Raspberry Pi 5

PCN 46 – Alternative sources of RAM

Notification of alternative sources of RAM device for Raspberry Pi 5.

Change of Raspberry Pi 5 PCB to Revision 4.

Figure 1.
Raspberry Pi 5 RAM Location

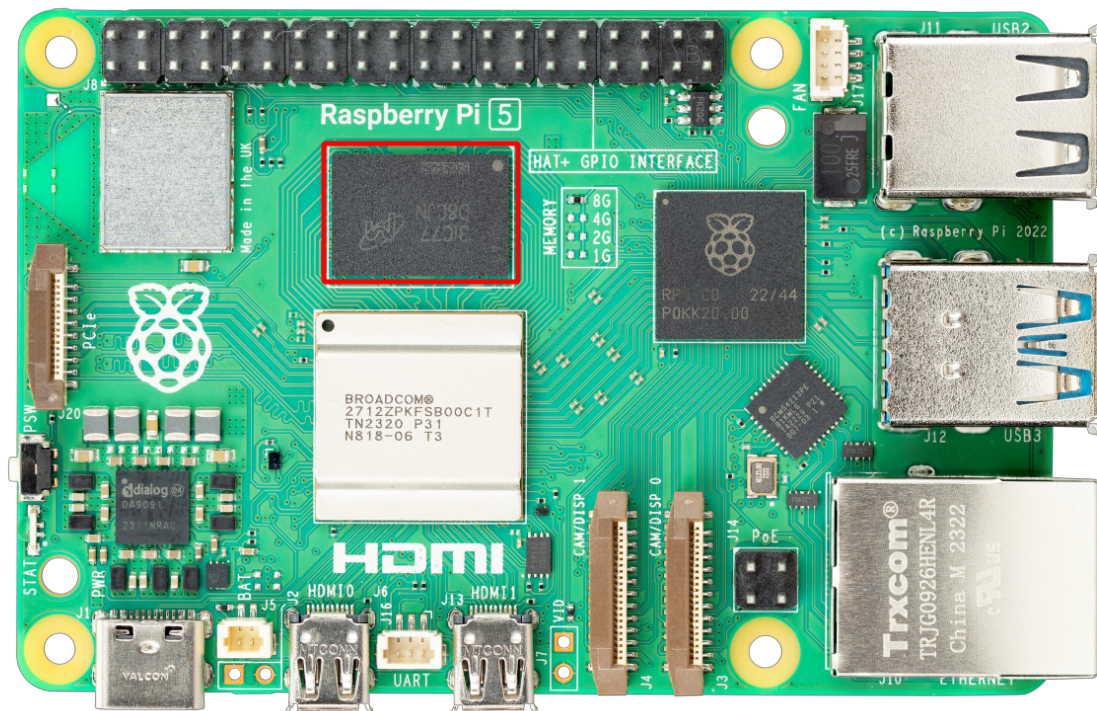
Multiple sources of RAM devices have been qualified for use on the Raspberry Pi 5.

The new product can be distinguished by examination of the RAM device for manufacturer and part number, as shown with the Micron part in the following image.

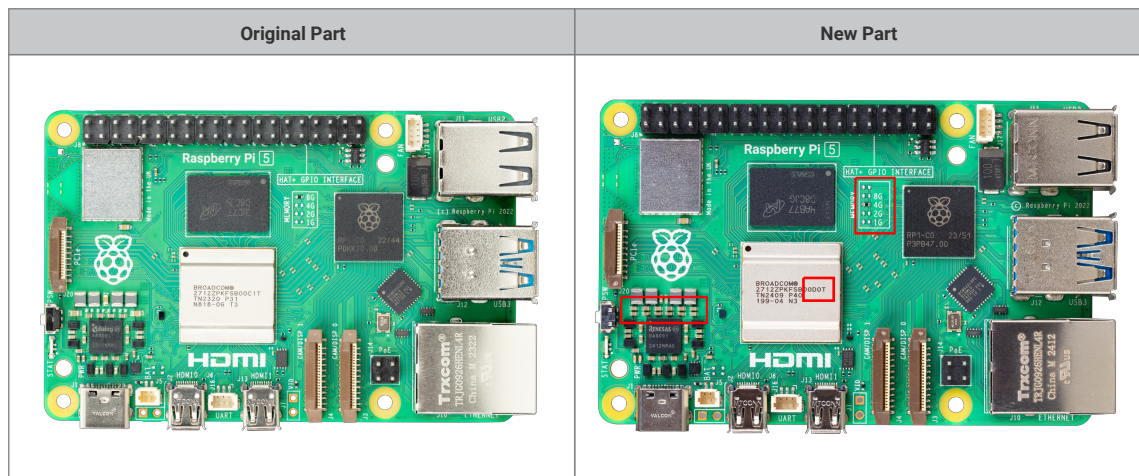
The new product can be distinguished by examination of the PCB. The revision 4 board has an extra link option in the memory box silkscreen on the top face of the PCB. There are now 6 similar components above the Dialog PMIC rather than 4. The final characters on the BRCM2812 device will contain **D0**.

See the red boxed areas on the images below for details.
